re: Geotechnical Response to City Comments
 Proposed Residential Building
 2458 Cleroux Crescent - Ottawa
to: Melmar Group – Mr. Marc Nakhle – info@melmargroup.ca
date: July 20, 2023
file: PG5973-MEMO.01

Paterson Group Inc. (Paterson) prepared the current memorandum to provide responses to the geotechnical-related City of Ottawa comments. The following memorandum should be read in conjunction with the current Geotechnical Investigation Report (Paterson Group Report PG5973-1 Revision 1, dated April 1, 2022).

- ❑ Figure 1 – Horizontal Podium Waterproofing Tie In With Foundation Drainage System

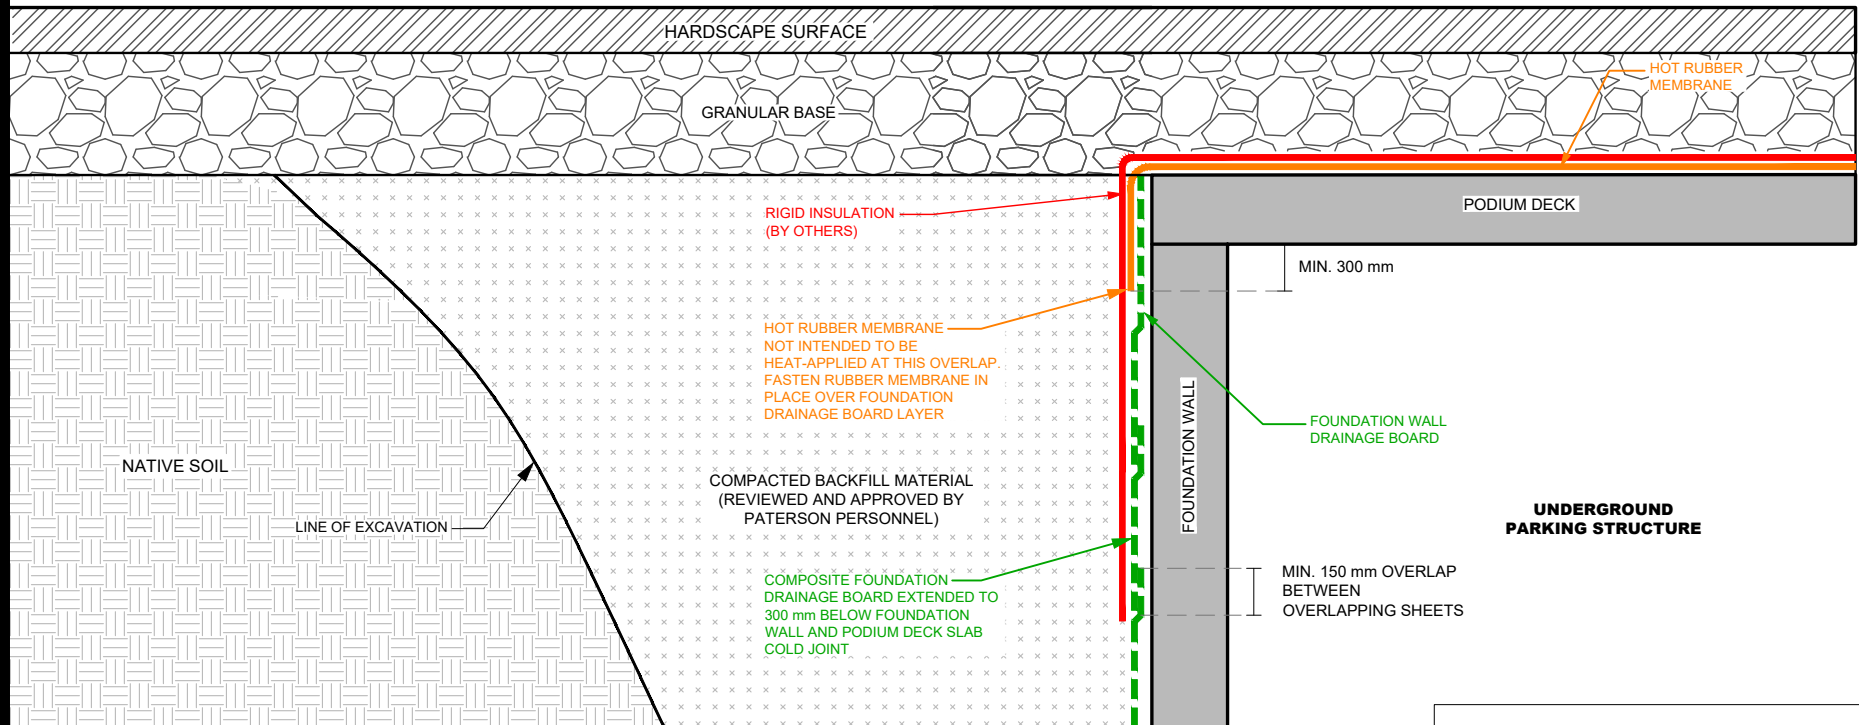
Comment 3: *A French drain is proposed at the top of the underground parking. Please provide recommendations for the top of parking level protection.*

Response: Based on our review, the recommendations provided in Section 6.1 of the current Geotechnical Investigation Report PG5973-1 Revision 1, dated April 1, 2022, would address the presence of the proposed drainage swale located above the proposed parking garage podium. However, further to this, it is recommended that waterproofing of the podium deck slab and termination of the foundation drainage board be undertaken as described in Figure 1 – Horizontal Podium Waterproofing Tie In With Foundation Drainage System attached to this memorandum.

In summary, a waterproofing membrane should be applied to the horizontal podium deck slab surface and the buried portion of the foundation wall between the podium deck slab and finished grade. It is recommended to extend this membrane vertically down the foundation wall and a minimum of 300 mm below the construction joint between the foundation wall and podium deck slab. The bottom-most endlap of the waterproofing membrane extending over the drainage board should be installed loosely against the drainage board layer. This would mitigate heat associated with welding the rubber membrane from damaging the drainage layer. The loosely installed layer of membrane should extend below a minimum of 300 mm below the top endlap of the drainage board layer.

Reference should be made to Figure 1 – Horizontal Podium Waterproofing Tie In With Foundation Drainage System attached to the current memorandum for further clarification of the above-noted recommendations. Further, the above-noted items should be reviewed at the time of construction by Paterson personnel.
